TECHNICAL MEMORANDUM

Re: **RI Phase 2 Modification No. 5**
Nevada Environmental Response Trust Site
Henderson, Nevada
Ramboll Environ Project No. 21-41400C, M03B

Figure
1

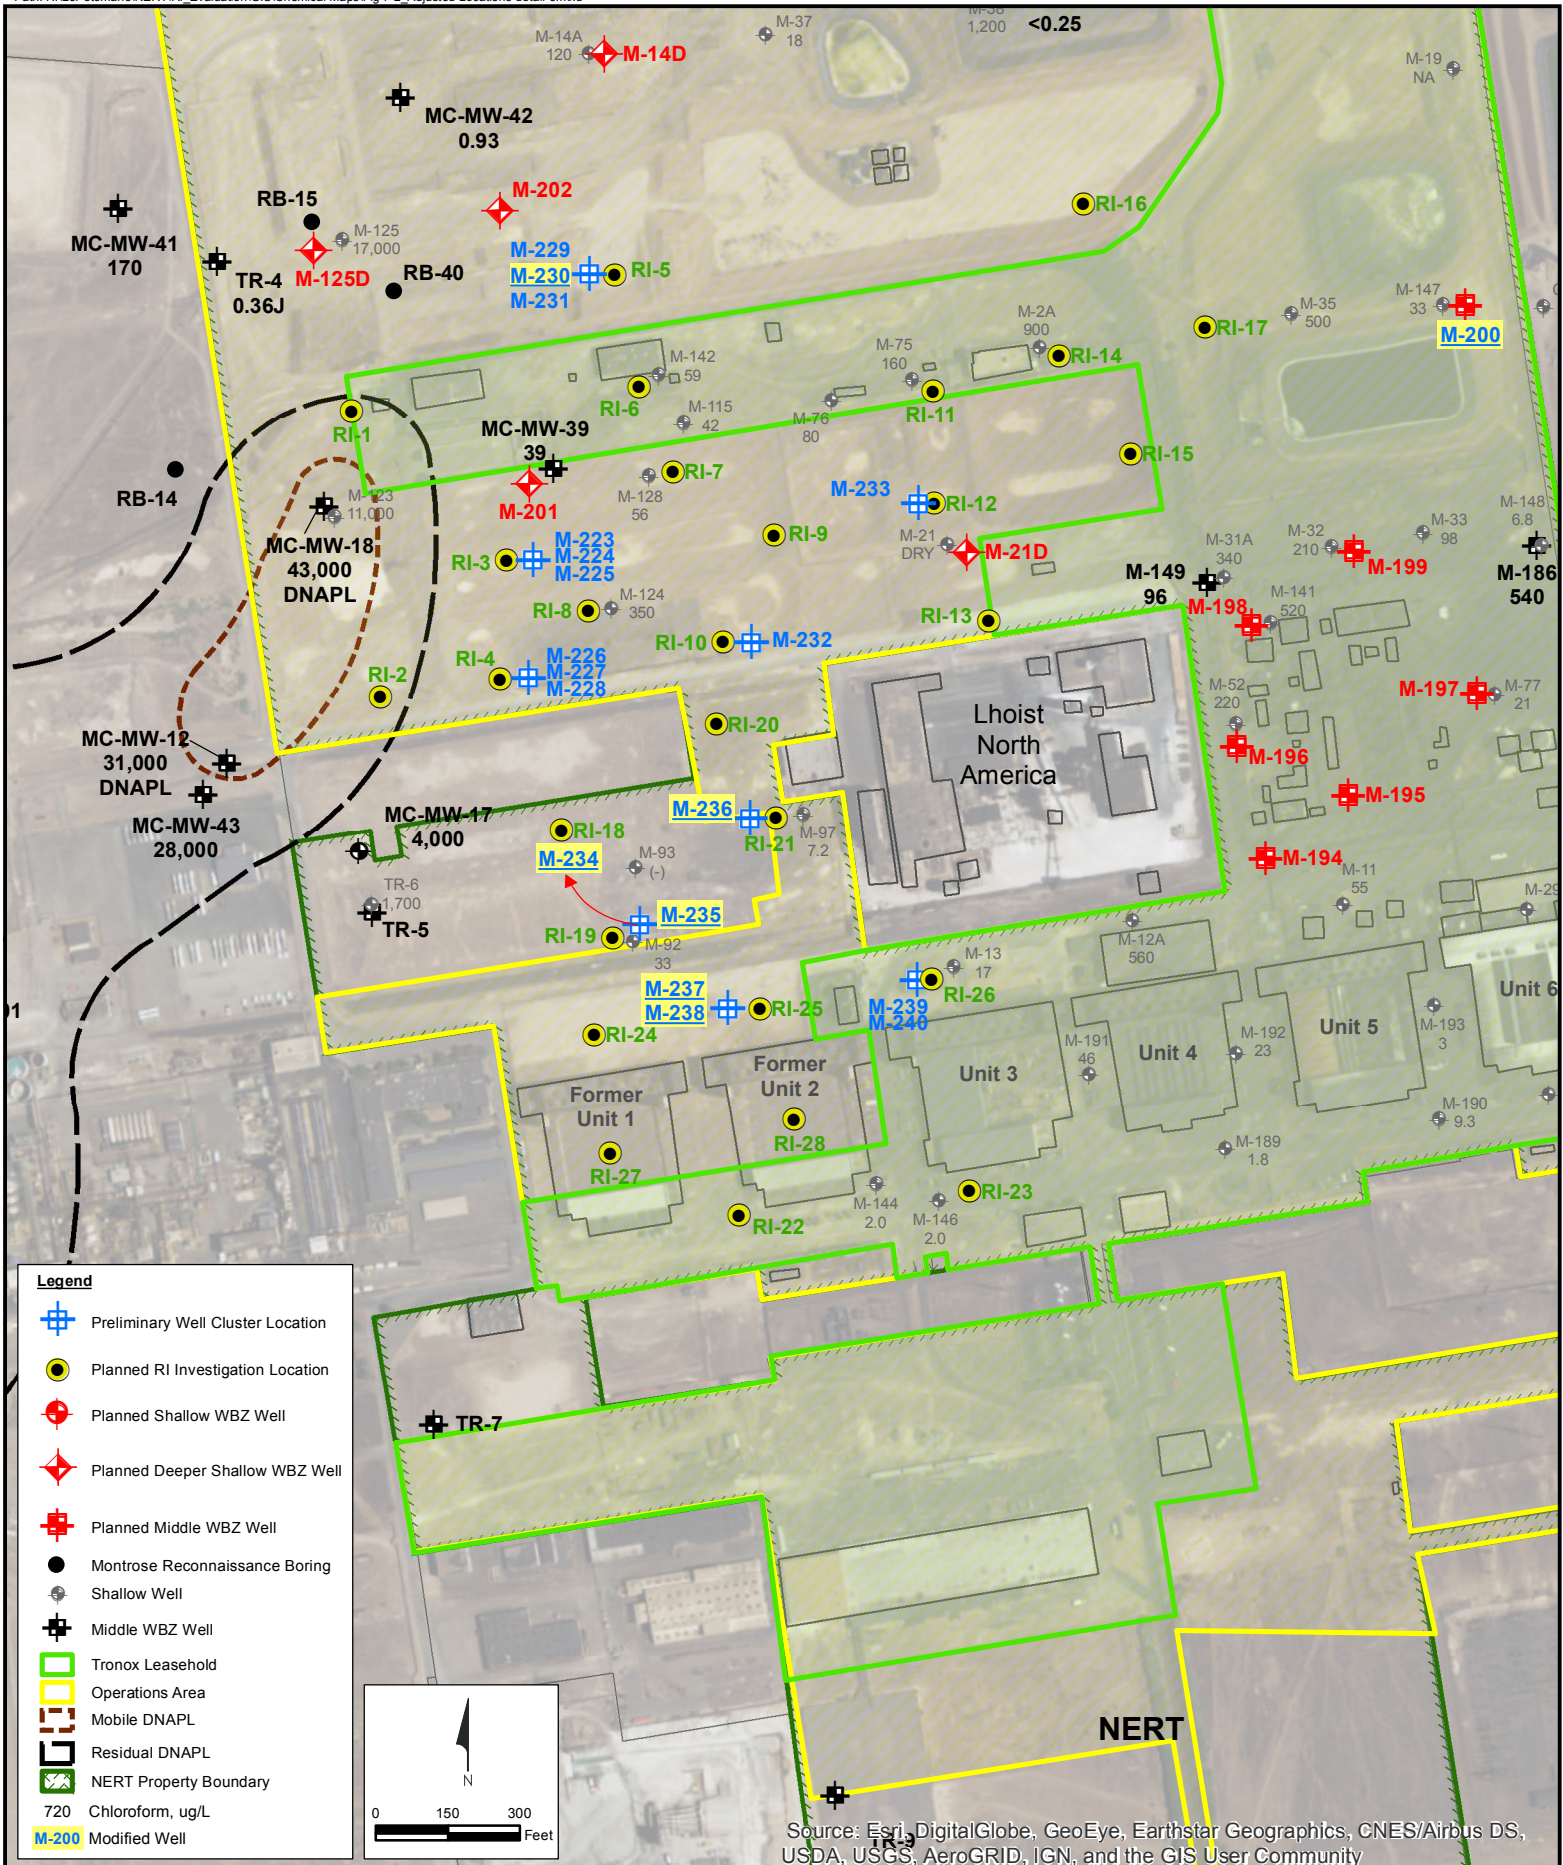
The well construction modifications and the rationale for the modifications are summarized in Table 1, and the well locations are shown on Figure 1. In general, well screens are being raised or lowered to align with the actual depth of the target zone at each boring based on conditions encountered during drilling and preliminary soil concentration data.

In addition to the well screen adjustments detailed in Table 1, Ramboll Environ is proposing to relocate well M-234 from the original planned location adjacent to boring RI-19 to a new location adjacent to boring RI-18 (about 200 feet north). Well M-234 was planned to be screened from 65-85 ft bgs in the deeper portion of the Shallow Water-Bearing Zone, but at boring RI-19 the preliminary soil concentrations in this depth interval were found to be relatively low. However, a zone of relatively higher soil VOC concentrations was encountered at depths of 70-80 feet in nearby boring RI-18, within the target screen interval of well M-234. Therefore, well M-234 will be relocated to monitor the zone of higher soil concentrations at boring RI-18.

New well M-235 will be installed adjacent to boring RI-19 as planned. Since the highest soil VOC concentrations in boring RI-19 were detected at depths of 90-100 feet, the screen for well M-235 will be modified to intercept this depth interval (adjusted to 85-105 ft bgs from the original 95-115 ft bgs, as detailed in Table 1).
